FARRAGUT MUNICIPAL PLANNING COMMISSION

AGENDA

March 16, 2023

Gordon Farragut Medical Office Building Initial Staff Comments on Site Plan.pdf Markup Summary

ROBERT G. CAMPBELL & ASSOC., L.P. CONSULTING ENGINEERS KNOXVILLE, TENNESSEE	FARRAGUT POINTE INC TOWN OF FARRAGUT, TENNESSEE	BOUNDARY SURVEY	DESIGNED BY RGC&A	CHECKED BY RGC	SCALE 1"=20'	SHEET C0.1
NO.	DATE	DESCRIPTION	BY					CHKD.	DRAWN BY RWM	DATE 02/28/2023	
REVISIONS

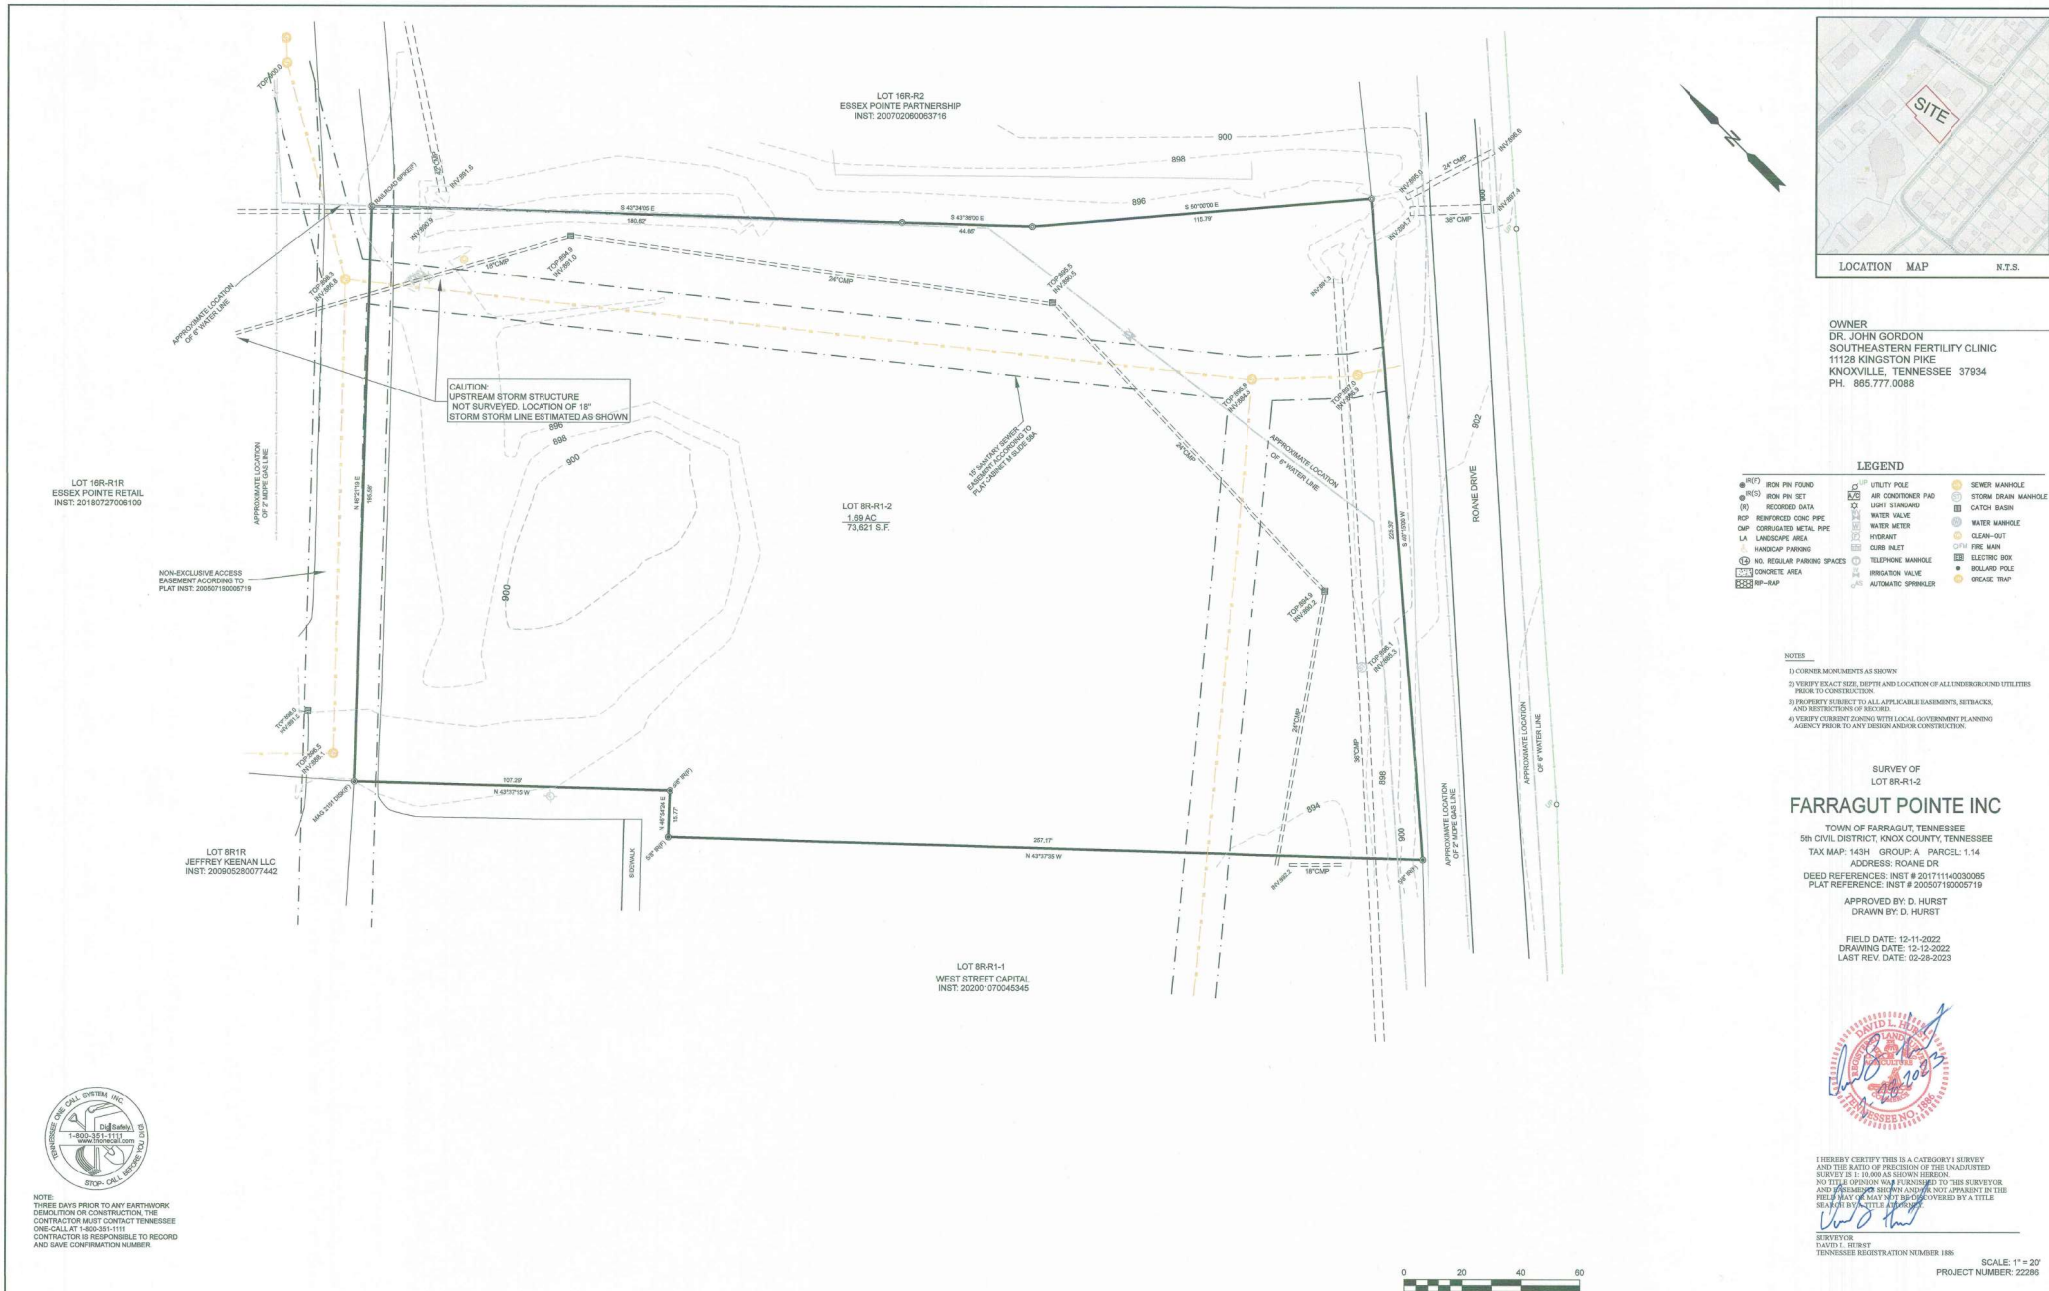
please show existing contours.

Please show the existing conditions for this phase rather than the finished conditions.

Please show the existing conditions for this phase rather than the finished conditions.

DESIGNED BY RGC&A	CHECKED BY RGC	SCALE 1"=50'	SHEET NO. C5.1
DRAWN BY CLD	DATE 03/06/2023	JOB NO. 22286	OF 4 SHEETS

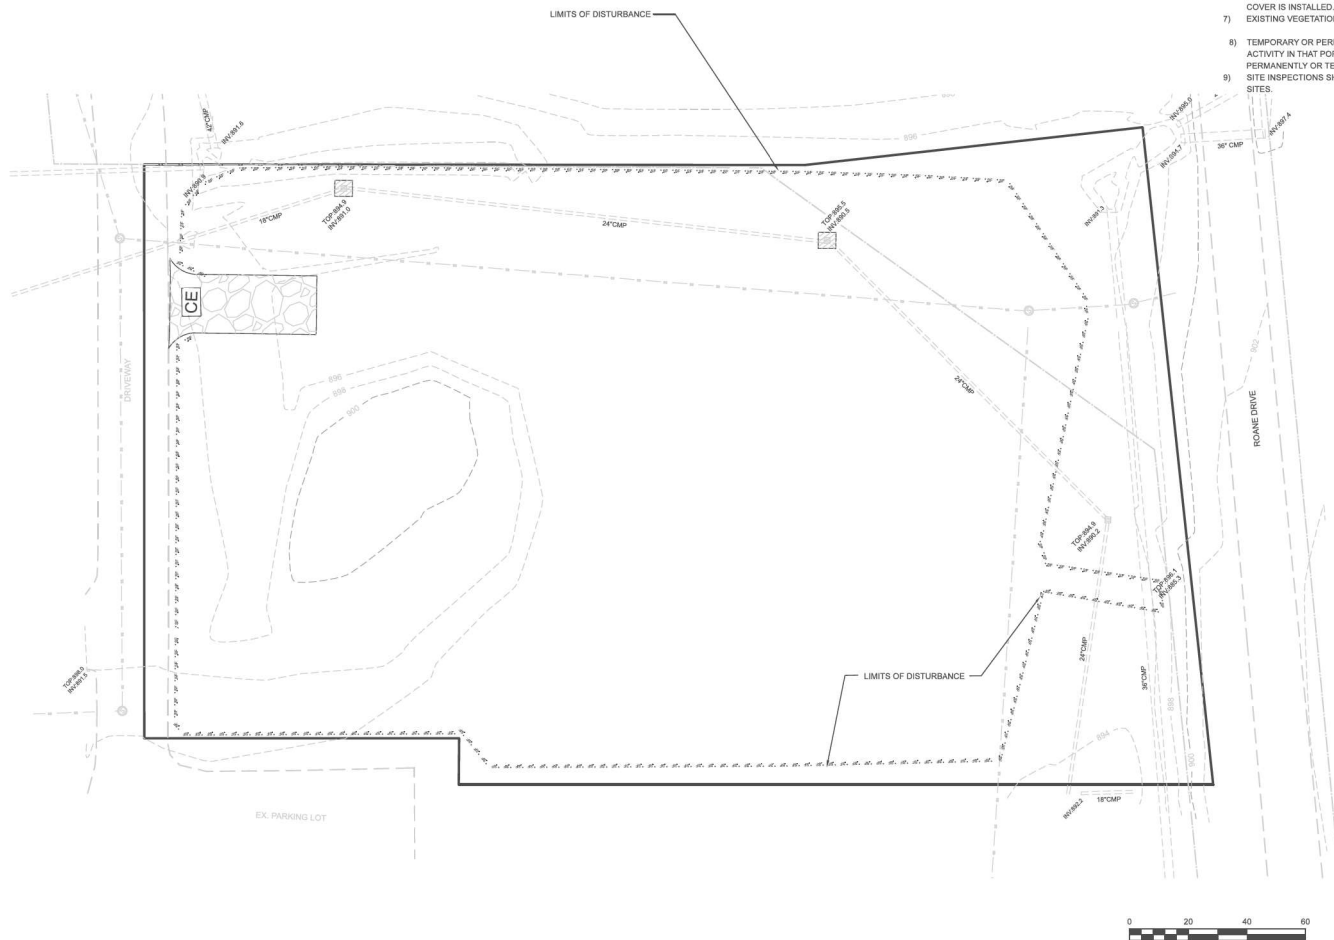
Silt fencing not approved for areas of concentrated flow. Please remove the last statement of Note 2.

These notes do not apply to the construction entrance. Remove.

EXISTING PAVEMENT
SILT FENCE
CONSTRUCTION ENTRANCE
Inlet protection needs to be added to legend

Inlet protection needs to be added to legend

Please add that EPSC measures must be repaired, replaced or modified within 7 days of identifying the deficiency/need

Please add note stating the on site record keeping requirements as stated in the CGP.

L100

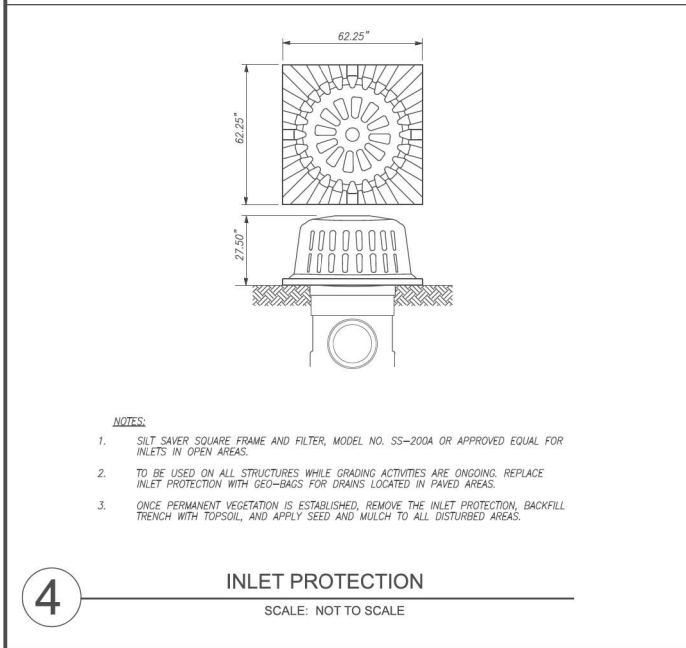
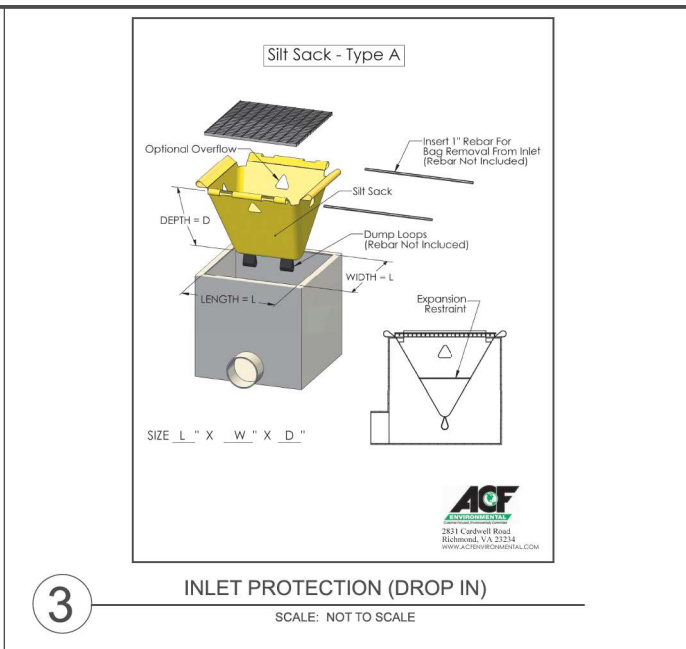
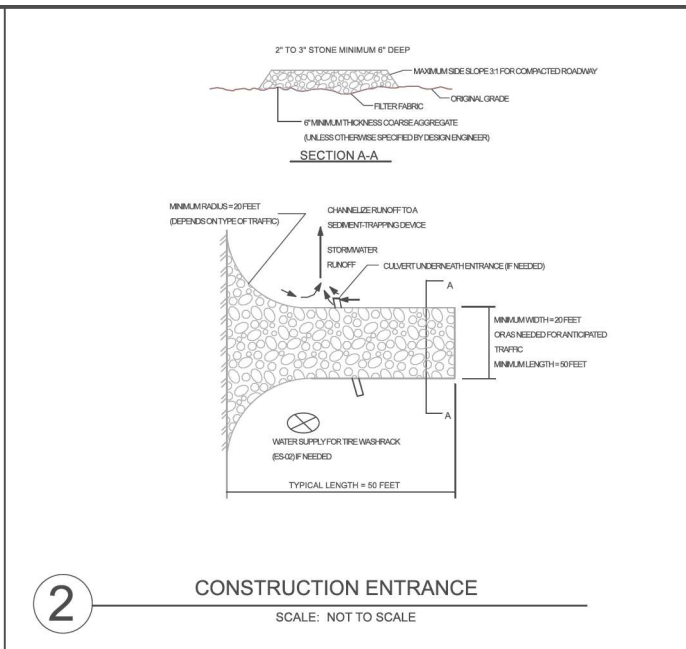
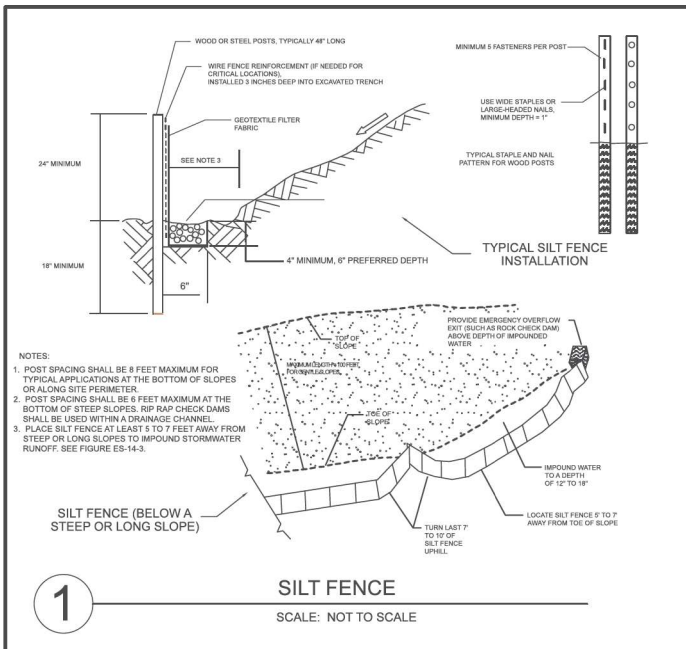
The tree plan does not identify larger trees along east property line. This area will change on the revised site plan since the dumpster will have to be relocated to at least 10 feet from the side property line.

The tree plan does not identify larger trees along east property line. This area will change on the revised site plan since the dumpster will have to be relocated to at least 10 feet from the side property line.

Please provide the information required for a tree preservation/removal plan for the Tree Protection Ordinance.

Please provide the information required for a tree preservation/removal plan for the Tree Protection Ordinance.

FRONT ELEVATION - 100% BRICK

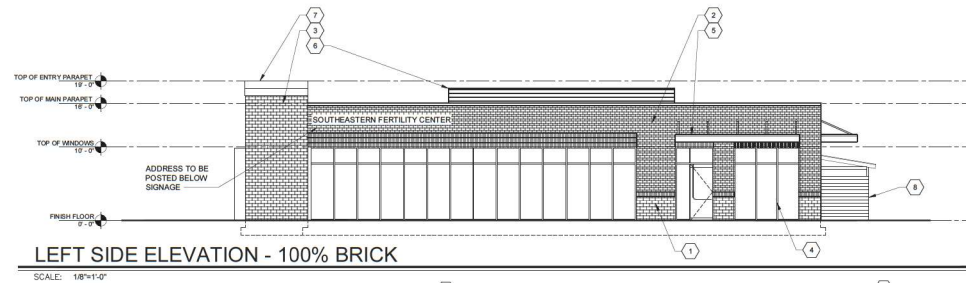
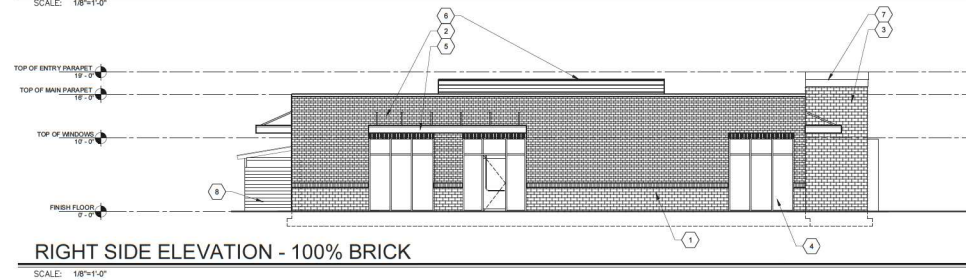
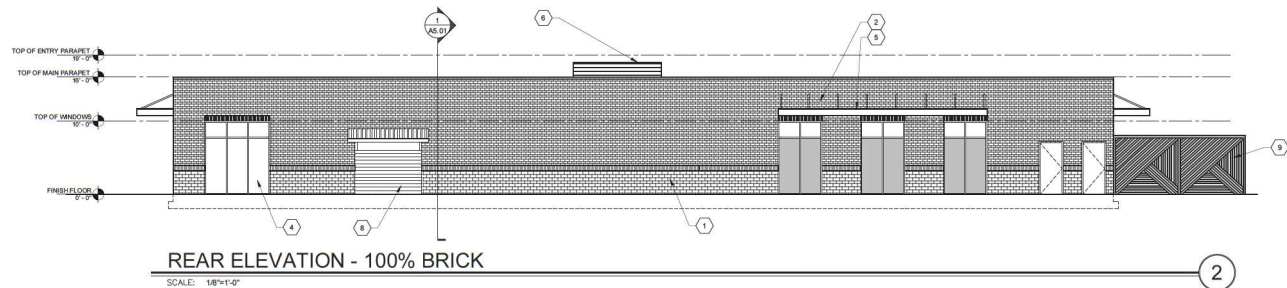
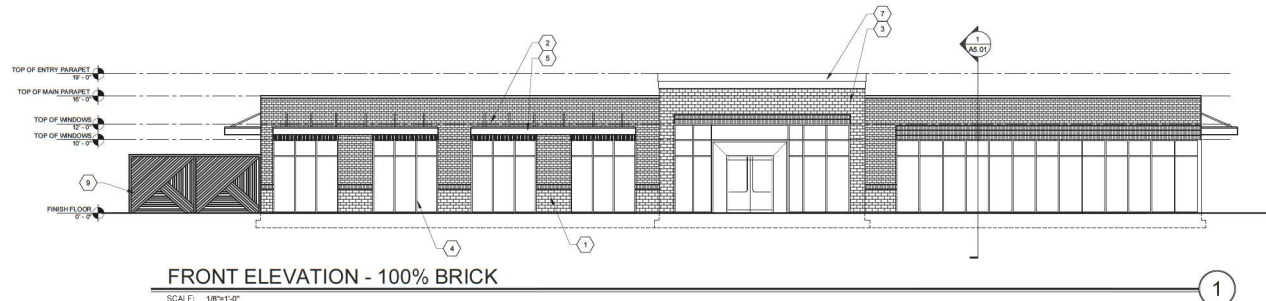
Please provide % of brick for each elevation, exclusive of windows and doors. It looks like the building is all brick but just needed to note this on the plan sheets.

Please provide % of brick for each elevation, exclusive of windows and doors. It looks like the building is all brick but just needed to note this on the plan sheets.
